**VILLAGE OF SOUTH BLOOMING GROVE
PLANNING BOARD
Regular Meeting
July 20, 2023**

**Comments Questions & Concerns for 3 & 5 San Marcos
Drive**

**Three lot Subdivision with semi-attached dwellings
Proposition**

Plan Review

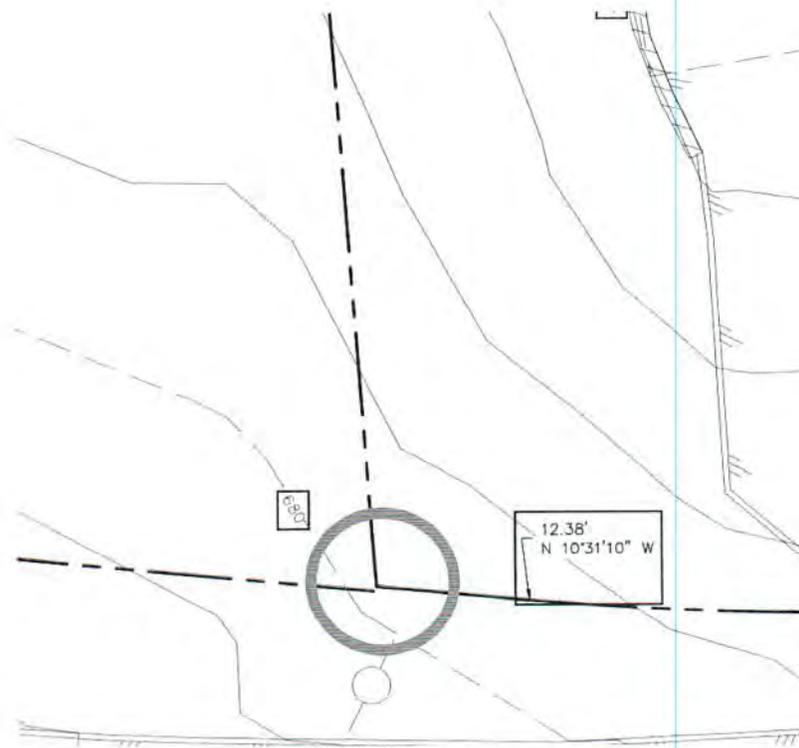
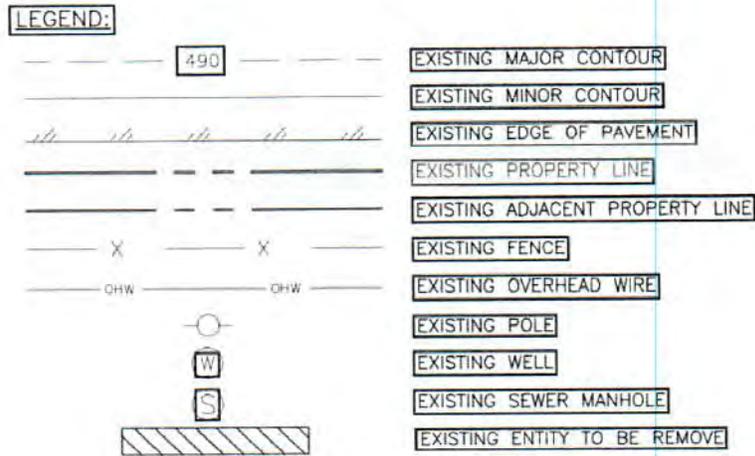
The lines on your plan don't appear to connect. See the shared boundary line between the two lots, then look where it intersects the existing streetline of San Marcos Drive.

Where did you get the boundary lines that are shown on these plans?

I am not seeing one actual piece of boundary evidence shown at any of the boundary corners on these plans. I am unsure how you are proposing retaining walls that follow along and are just inside the boundary lines without actually determining the boundary lines in real life. *These look like they were taken off from the Orange County GIS program.*

Did you locate the boundary evidence and do the deed study to establish the boundaries for these lots?

Where is the actual boundary survey of this property?
